Access Compliance Report

Public Rights-of-Way

(Curb Ramps)

Intersection ID: 44932	Main Street: NATHAN_DR	Cross Street: BRUMIT_LN	Location: SW
ADA ID: 0777D2F470B6	Ramp Type: PerpDiag	Initial Pass/Fail: Fail	Overall Compliance: No
		Severity Score: 8.75

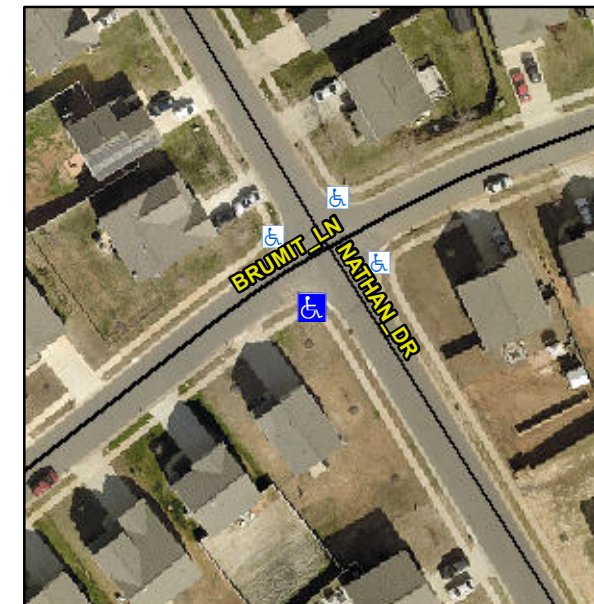
Compliance	Description	Data	Compliance	Description	Data
N/A	Ramp Length (in)	51.0	Yes	Ramp Slope (%)	5.5
No	Ramp Width (in)	46.0	Yes	Ramp XSlope (%)	1.1
N/A	Flare Type LT	N/A	N/A	Flare Type RT	N/A
N/A	Flare Slope LT (%)	N/A	N/A	Flare Slope RT (%)	N/A
N/A	Flare Traversable LT?	N/A	N/A	Flare Traversable RT?	N/A
N/A	Landing Length (in)	N/A	N/A	DWS Provided?	N/A
N/A	Landing Width (in)	N/A	N/A	DWS Contrast?	N/A
N/A	Landing Slope (%)	N/A	N/A	DWS Length (in)	N/A
N/A	Landing X Slope (%)	N/A	N/A	DWS Full Width?	N/A
N/A	Landing Curb? (Y/N)	N/A	N/A	DWS Offset (in)	N/A
N/A	Shared Landing?	N/A			
N/A	Gutter Ponding?	Yes	N/A	Gutter Slope (%)	N/A
N/A	Gutter Lip Ht (in)	N/A	N/A	Gutter X Slope (%)	N/A
N/A	Painted X Walk1?	No	N/A	Painted X Walk2?	No
	X Walk 1 Direction	To E		X Walk 2 Direction	To N
N/A	X Walk 1 Width (in)	N/A	N/A	X Walk 2 Width (in)	N/A
	X Walk 1 Slope (%)	2.9		X Walk 2 Slope (%)	0.7
	X Walk 1 X Slope (%)	0.7		X Walk 2 X Slope (%)	4.5

N/A	Ramp inside XWalk1?	N/A	N/A	Ramp inside XWalk2?	N/A
	Road Slope (%)	1.1	N/A	Clear Space?	N/A
	Road X Slope (%)	3.0	N/A	Clear Space to XWalk (in)	N/A
N/A	Any Obstructions?	N/A	N/A	Storm Grate/Utility Hazard?	N/A
	Obstruction Type			Storm Grate/Utility Type	
		N/A			N/A
		Yes		Surface Condition? (G/P)	Good

Remove & Replace Curb Ramp With Two New Directional Ramps or Equivalent.

R304.5.1
